Access Compliance Report Public Rights-of-Way (Pedestrian Signals)

Main Street: ORTEGA_HWY Cross Street: N/A Location: SE

ADA ID: SGRK211123123527 Signal Type: One Push Button-APS Overall Compliance: No Severity Scores: BTN 1: 25 BTN 2: N/A No BTN: N/A

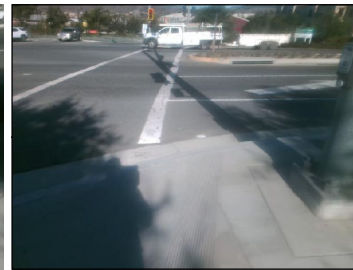
OC Std/PROW: MUTCD 4e.08, R404.2

Possible Solutions: Replace Signal Push Button With APS Button. Remove & Relocate Sign.
